PUBLIC NOTICE
CITY OF BEXLEY
ARCHITECTURAL REVIEW BOARD

- a. Application No.: ARB-19-24
Applicant: William T. Gruber & Dean Wenz
Owner: William T. Gruber
Location: 745 Francis Avenue

ARB Request: The applicant is seeking architectural review and approval to demolish the existing single-family dwelling, and allow a new single-family dwelling and detached garage to be constructed on the lot. Please Note: This application was tabled at the June 13, 2019 meeting of the Architectural Review Board.

The Gruber Residence
745 Francis Avenue Bexley, Ohio

① Site Plan
1" = 10'-0"

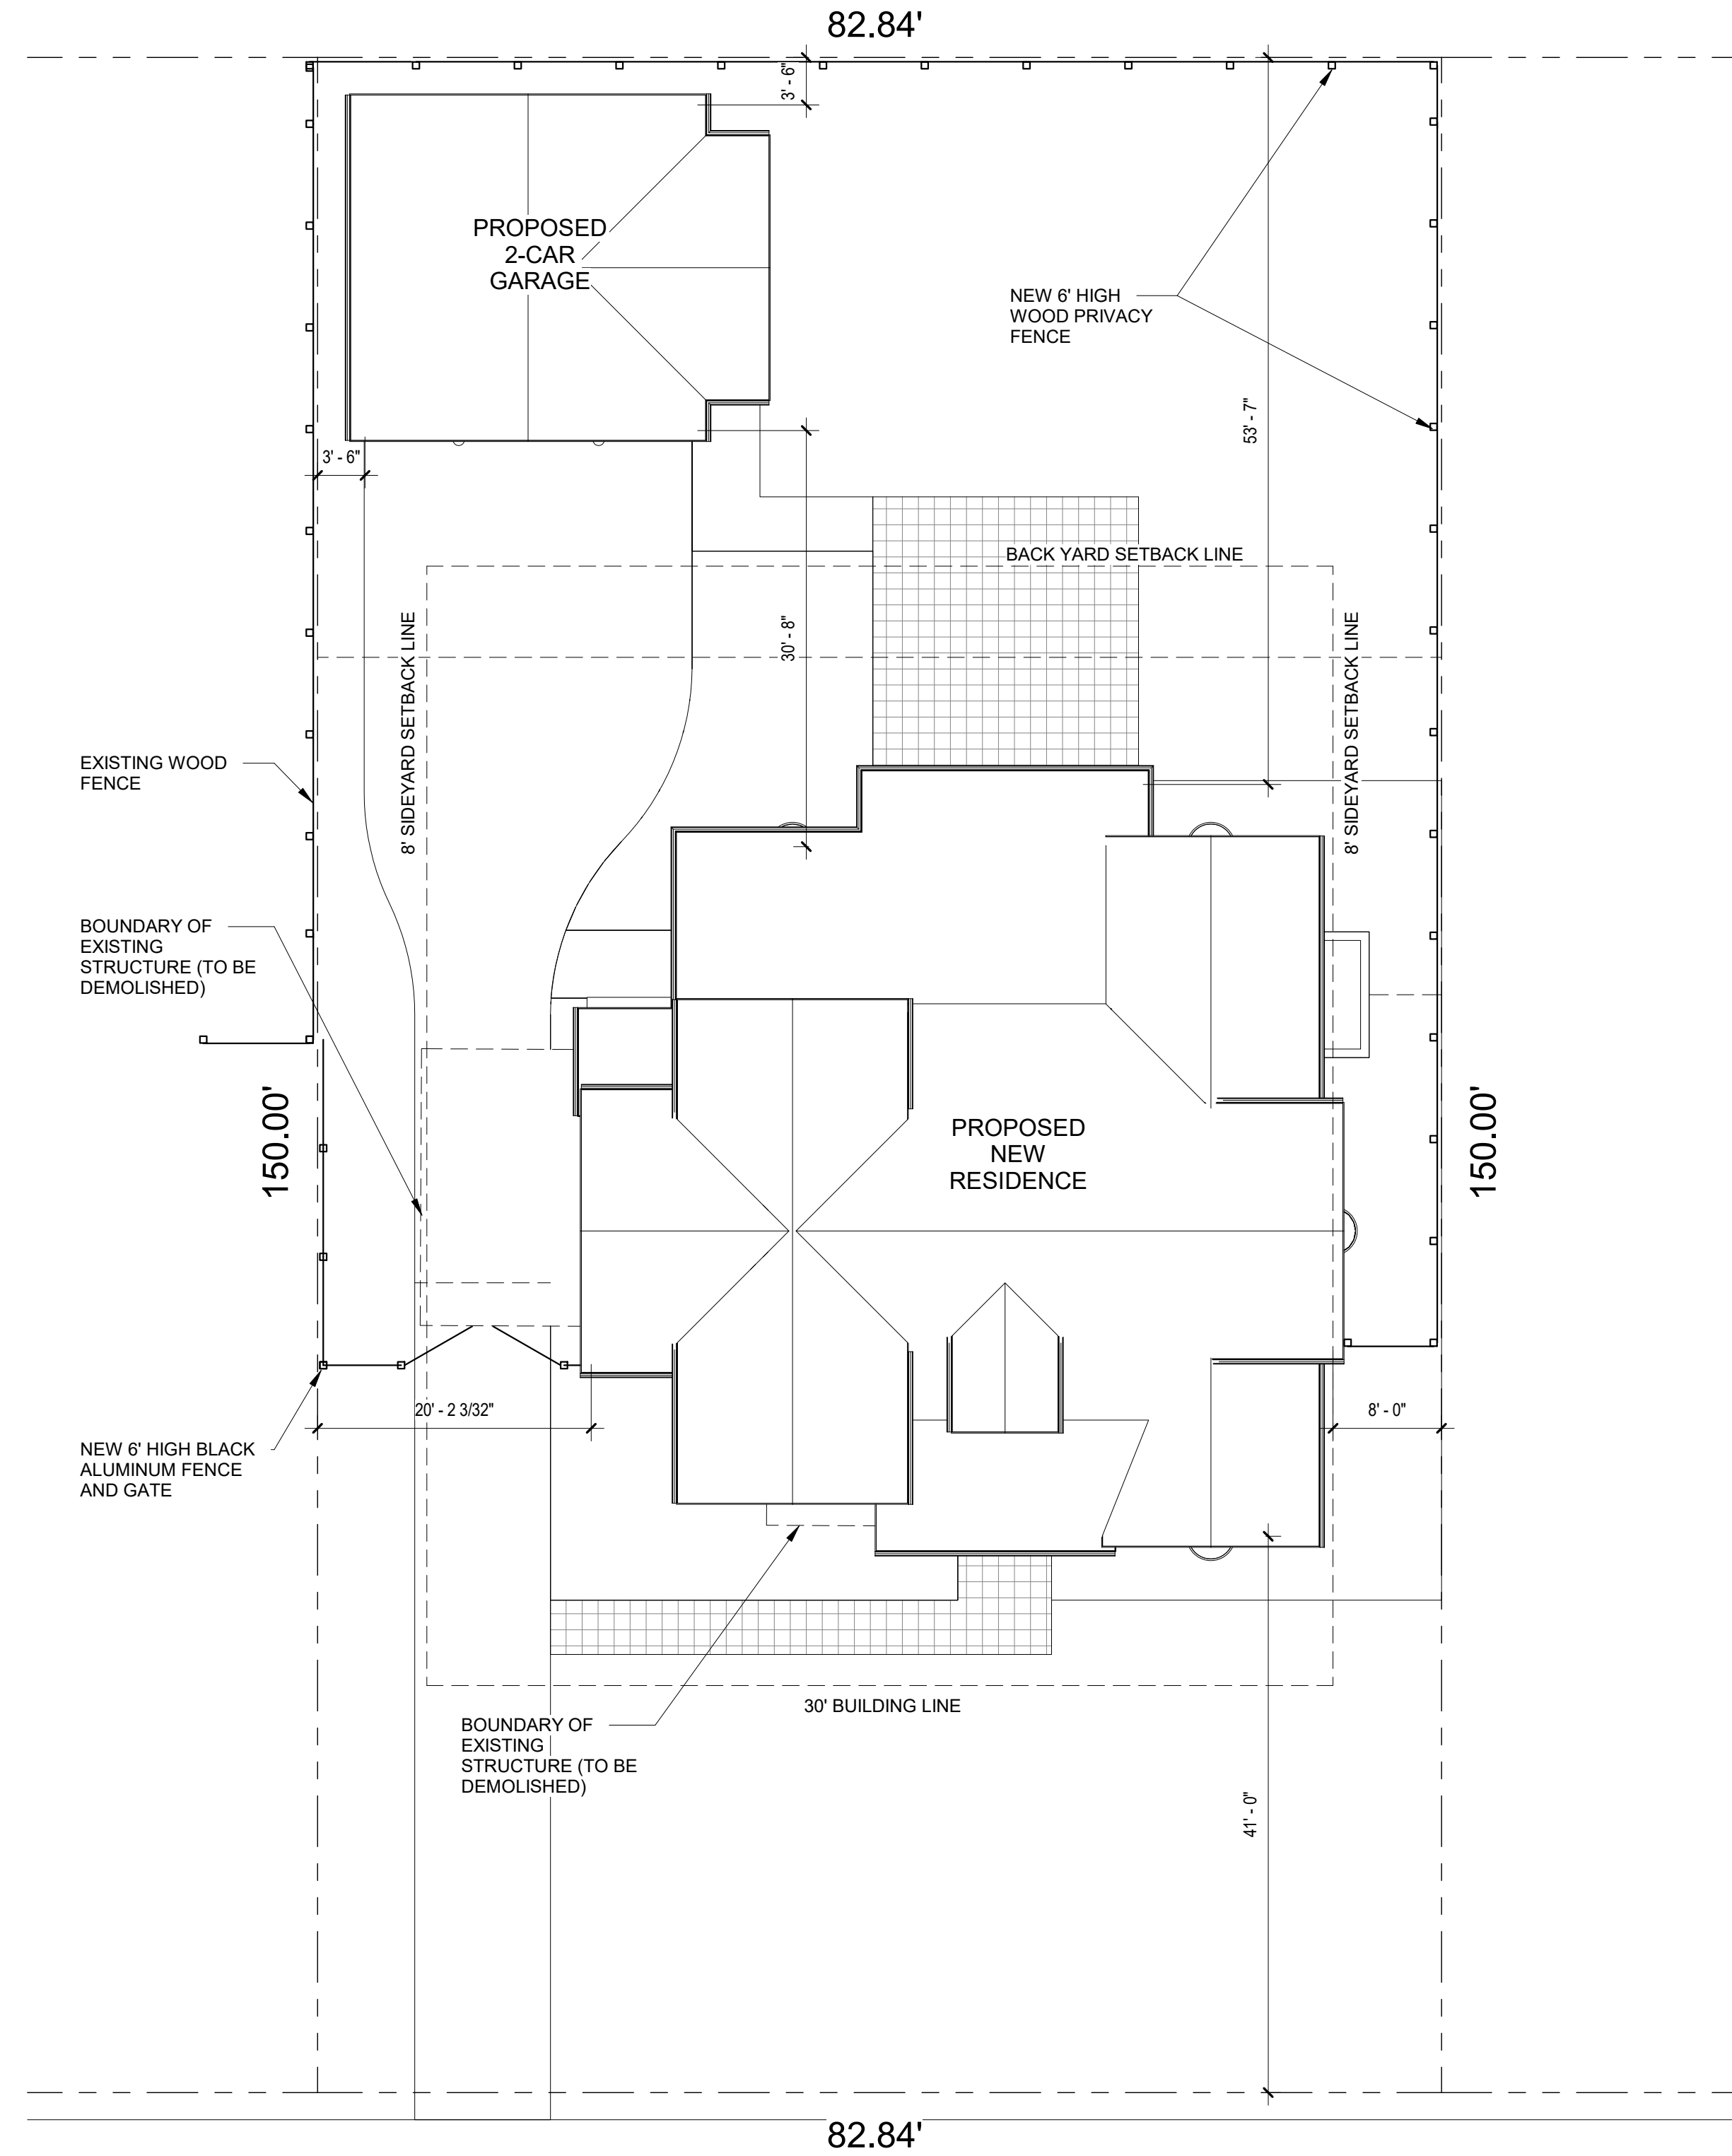
You also need to note which trees are existing and what trees will remain, and also a landscape plan for the new home, which can also be a condition of the approval, if it is not ready by the 9th of January.

Kathy, There is a landscape plan included with the submittal. I think it has all of the information you mentioned, but please let me know ASAP if it is insufficient. I am still planning on providing the context drawing you mentioned, but I haven't been able to get to it yet. Would you please call me when you get a minute to discuss the demolition?

① Front Elevation
3/16" = 1'-0"

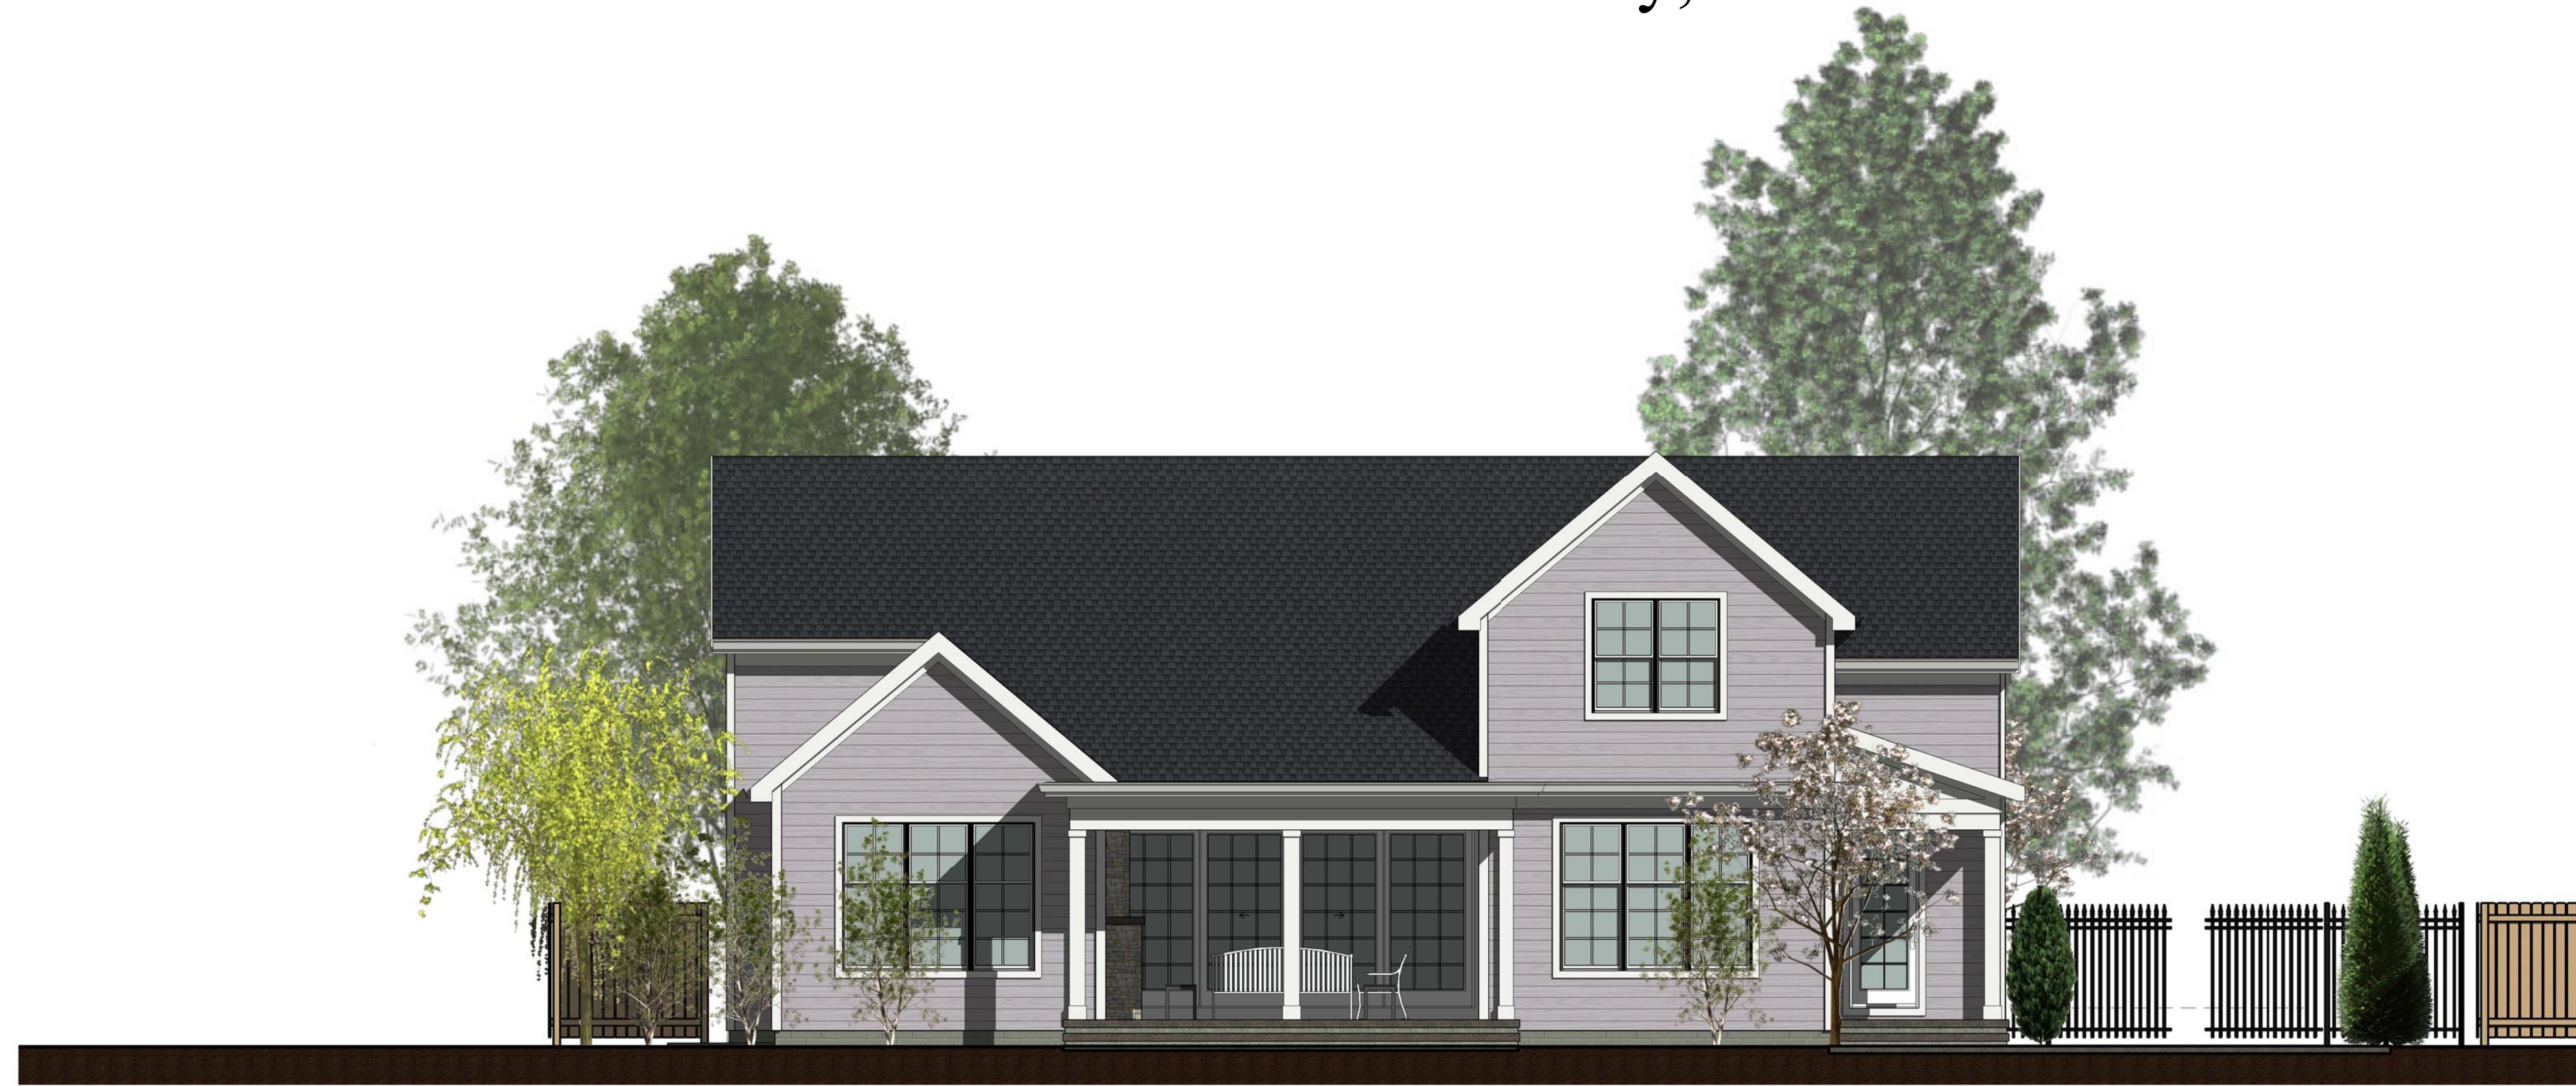
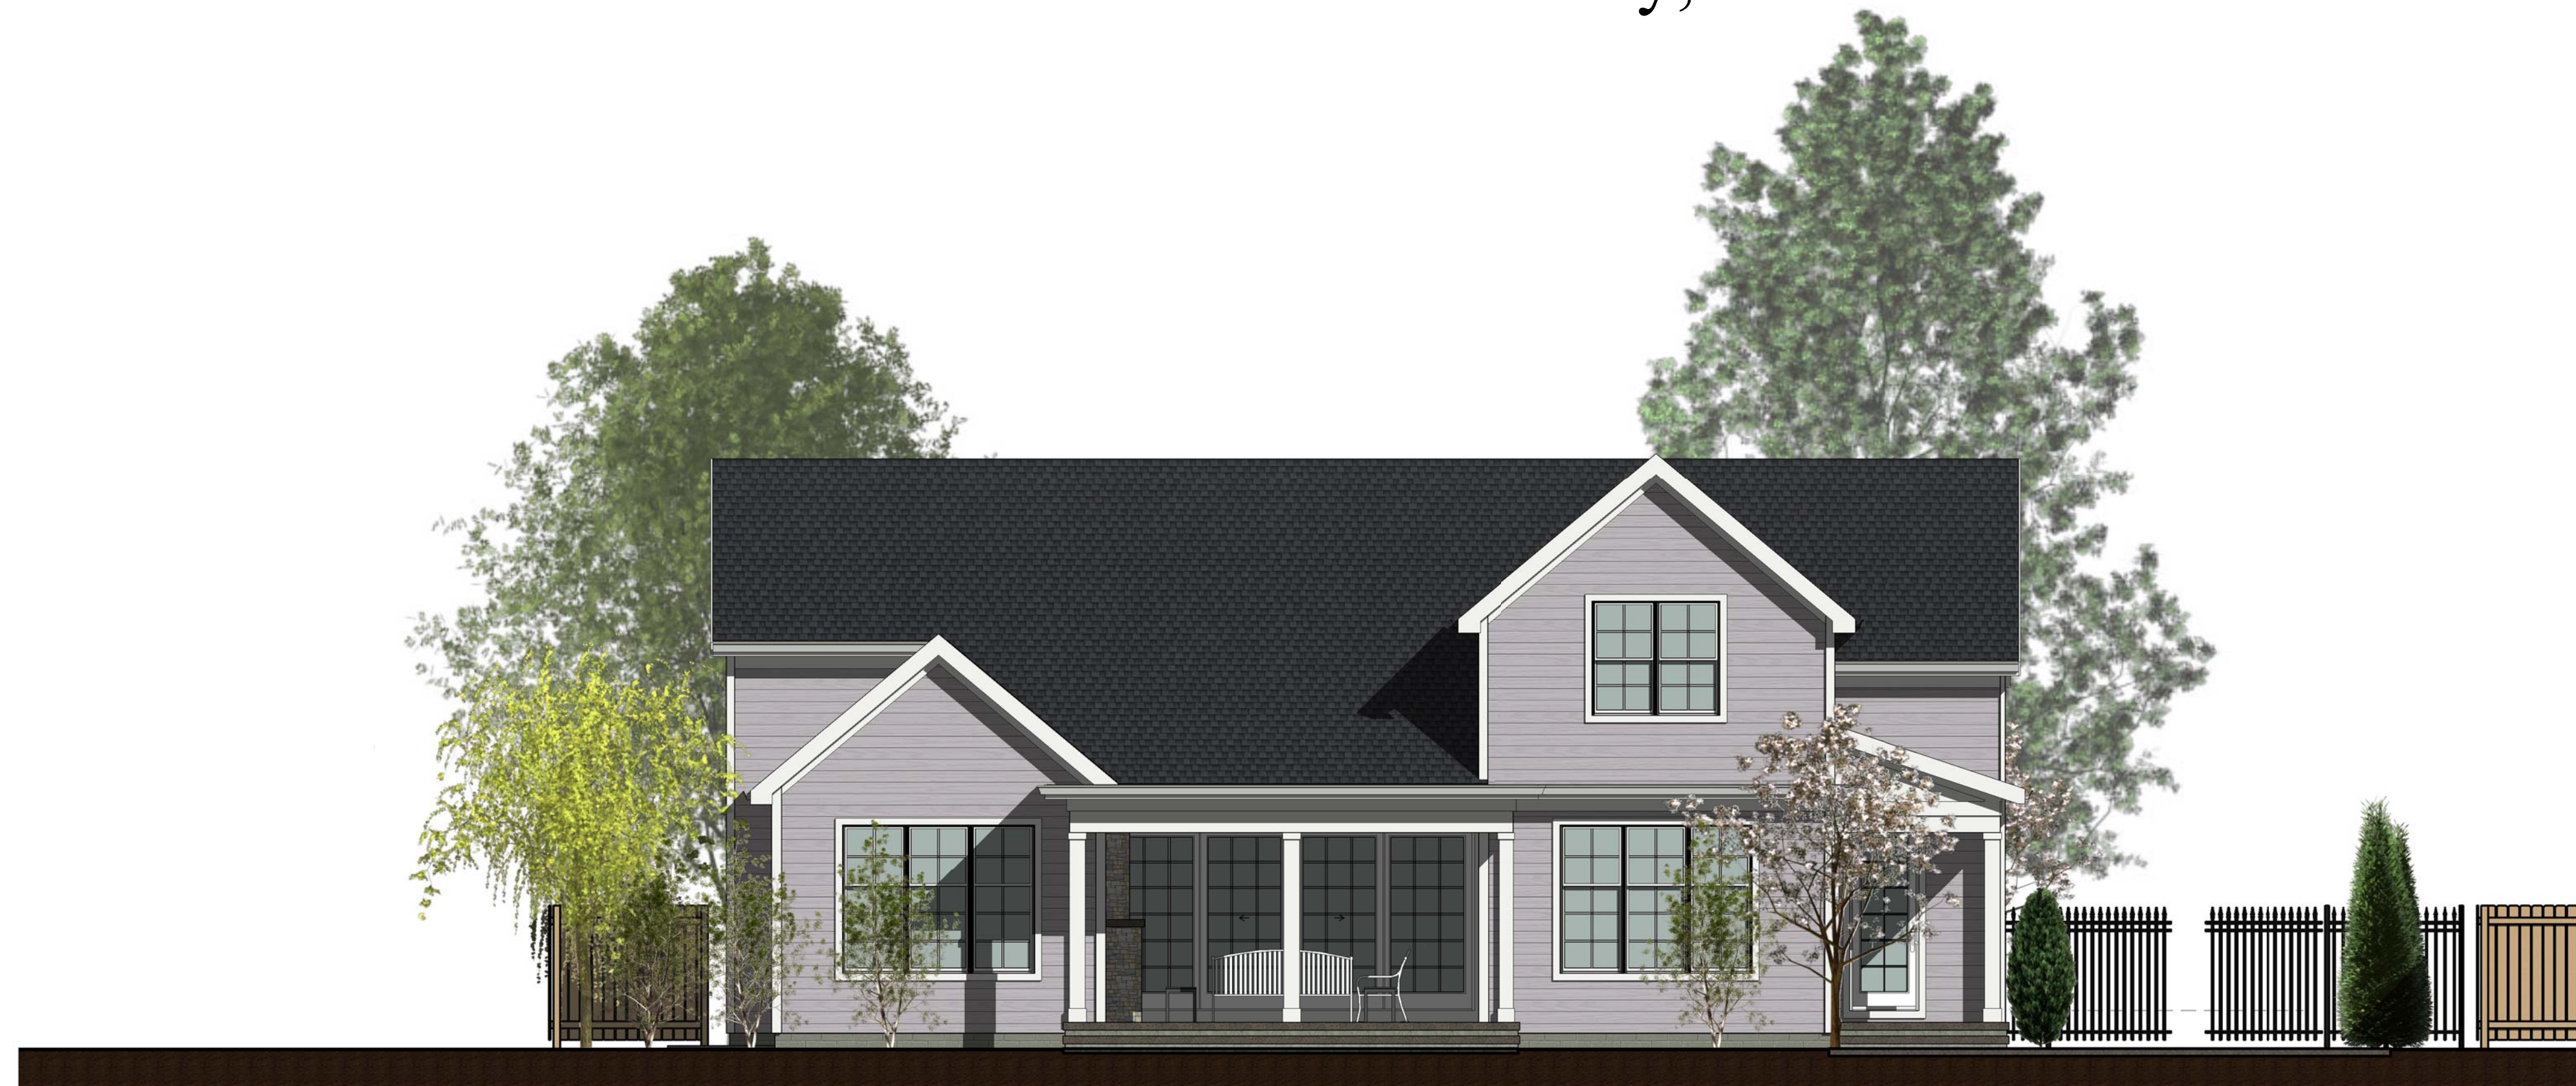
Dean - You really should show how this home looks in context with the neighboring homes - what the Board would expect to see, and shows how it fits into the size and scale of the block.

Hi Dean - I think it would be very helpful if you could bring a drawing or photo of the streetscape with the new home inserted into the drawing so that the Board can see its height/proportions/details, etc.... Its been something they ask for at just about every new build hearing.

Members of the Board stated that they do not necessarily object to demolishing a home that will be replaced with something better, but feel that the design in this proposal is not better than what is already there. The applicants said they will work with the Design Consultant to revise the proposal and asked the members of other changes to consider. Bardwell stated that the Board is not in the position to imply recommendations in order to meet Board approval. Bokor offered that the applicants have 3-dimensional representation of the proposal. Members commented that the proposed building lacks charm, and suggested the applicants take a look at cues in the surrounding homes, and that this was an opportunity to create something with character. Bardwell commented that the applicants should show the renderings in context, especially in regards to the broader perspective to the context of the street. The current grouping of residences are unique and frontages on this street are greater than on other streets in South Bexley. The lots are wider, have a spacious streetscape, and that the applicants should take advantage of that. Diverse styles of homes align the street, and Bardwell suggested the applicants walk along the street, and take a cue from what exists on the street now.
